# RENESAS TECHNICAL UPDATE

Product Category	MPU/MCU		Document No.	TN-SH7-A721A/E	Rev.	1.00
Title	SH7720 group and SH7721 group Note on Use of SIOF Slave Mode Receiver		Information Category	Technical Notification		
Applicable Product	SH7720 Group SH7721 Group	Lot No.	Reference Document	SH7720 Group, SH7721 Group hardware manual Rev.3.00 (REJ09B0033-0300)		
		All

Figure 1 SIOF Receive Data Sampling Timing in Slave Mode

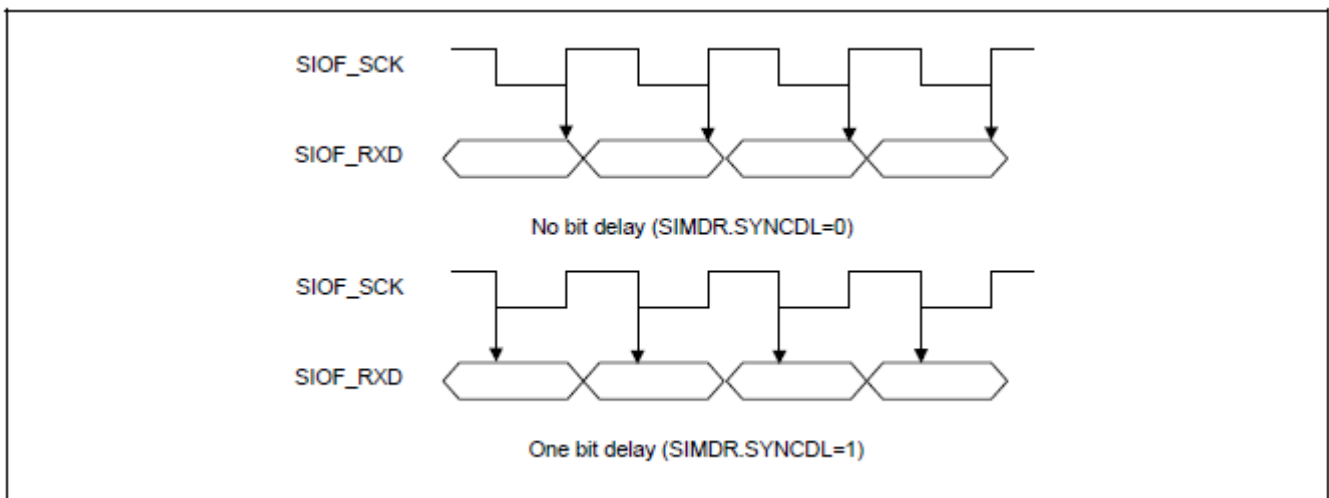
When using the receiver of the SIOF in slave mode, if specifying no bit delay (SIMDR.SYNCDL=0), the receive data is sampled at the rising edge of the SIOF\_SCK, then the hold time of the receive data may not be ensured.

Specify one bit delay (SIMDR.SYNCDL=1) for receiver like for transceiver in slave mode. Then the receive data is sampled at the falling edge of the SIOF\_SCK.
